### INTERPRETATION IC 62.1-2010-6 OF ANSI/ASHRAE STANDARD 62.1-2010 VENTILATION FOR ACCEPTABLE INDOOR AIR QUALITY

### Approved: January 18, 2014

**<u>Reference</u>**: This request for interpretation refers to the requirements presented in ANSI/ASHRAE Standard 62.1-2010, Section 2.3, regarding additional requirements for health care facilities.

Figure 1 – Outside air ACH of all cases, using both standards.

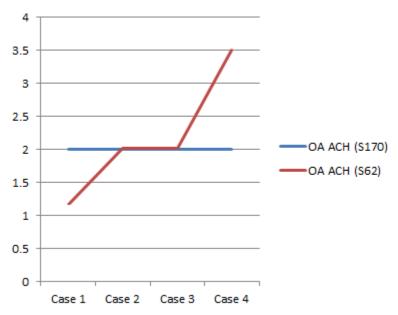
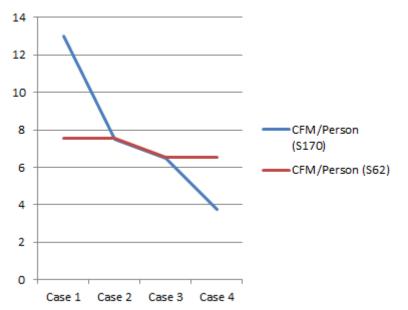
Resultant outside air flows, in ACH, are shown in **Figure 1** below. Air change per hour is constant using S170. ACH rate increases from case 1 to case 4 using S62.1.

Resultant outside air flows, in cfm per person, are shown in **Figure 2** below. Cfm per person is fairly constant using S62.1. It decreases from case 1 to case 4 using 170.

Figure 3 – Percent difference between S170 and S62 outside air cfm per person

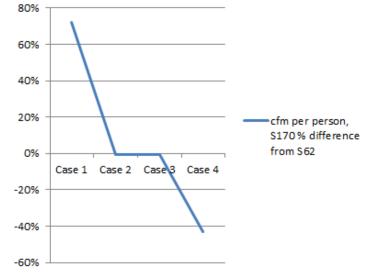
The percent difference in cfm per person required by each standard is shown in **Figure 3** below. For cases 2 and 3, the standards are aligned. Using S170, case 1 requires 72% more outside air than S62.1, This will increase energy use and the need for humidity control in the space. Using S170, case 4 requires 43% less outside air than S62.1. The fully occupied room would not have minimumaly acceptable indoor air quality, as defined by S62.1.

**Comments:** Compliance with Standard 62.1 requires that no less than the ventilation air specified therein be provided (as well as meeting all other requirements of the Standard). Standard 170 contains requirements which are more specific to the spaces in question and meeting the Standard 170 requirements may be appropriate in many cases. If compliance with both standards is required, than the supplied ventilation must be no less than the larger of the two ventilation rates specified by the two standards.
